GT-tronics HK Ltd.

BC05-ROM Bluetooth Module

Rev. 02

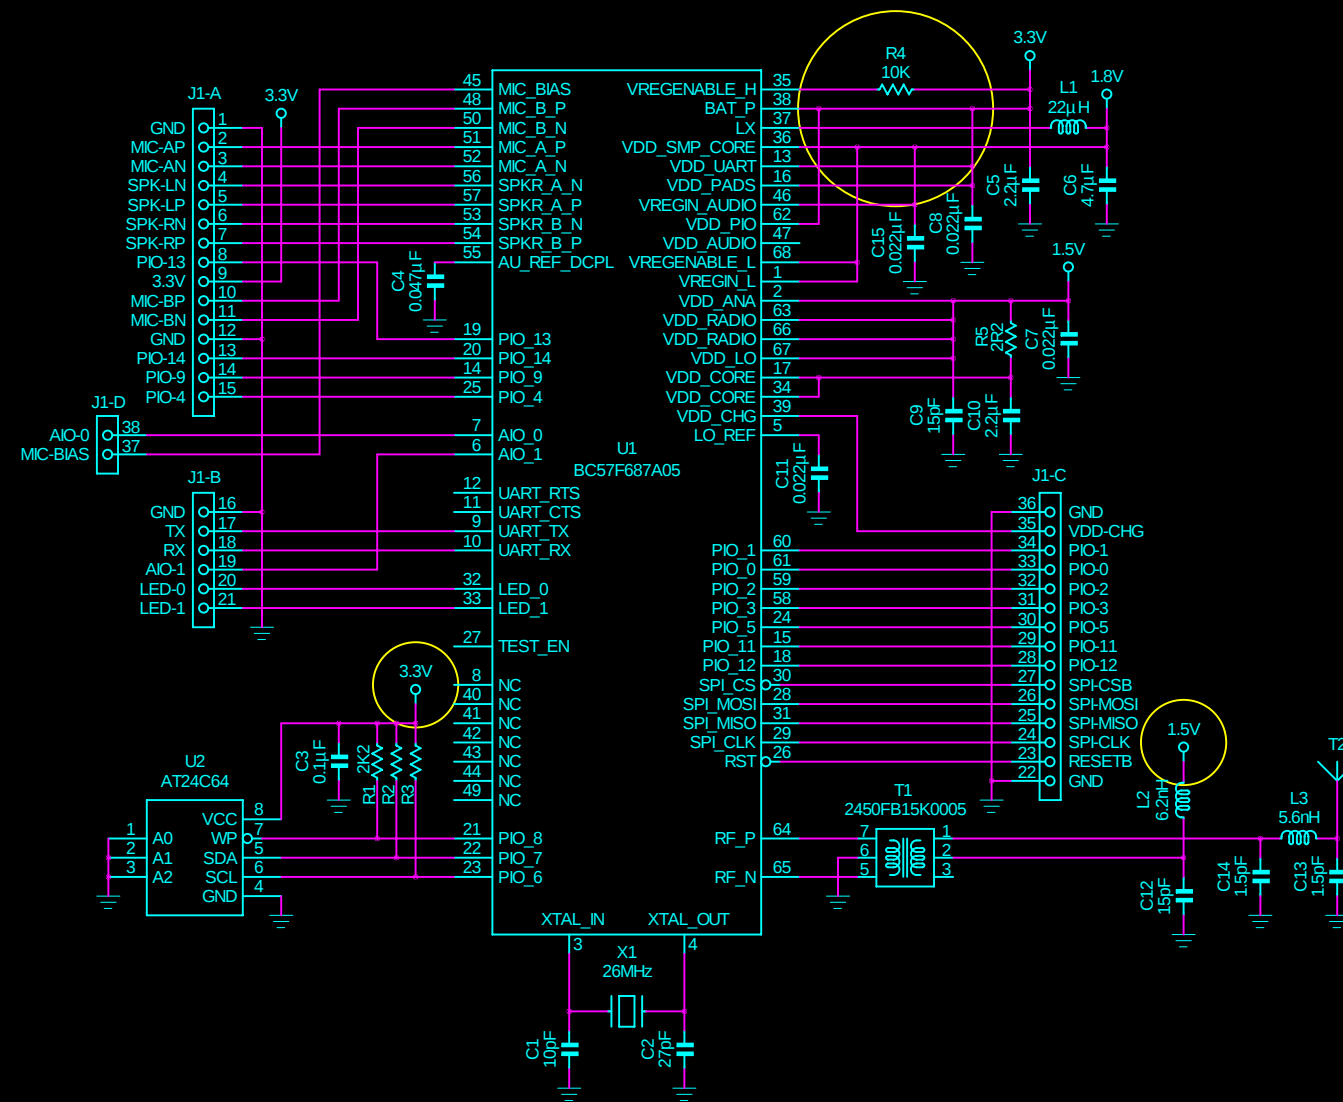
1. U1 pin 13 VDD_UART powered from 3.3V (old design is 1.8V)
2. U1 pin 16 VDD_PADS powered from 3.3V (old design is 1.8V)
3. U1 pin 62 VDD_PIO powered from 3.3V (old design is 1.8V)
4. U2 pin 8 powered from 3.3V (old design is 1.8V)
5. L2 pin 2 powered from 1.5V (old design is 1.8V)
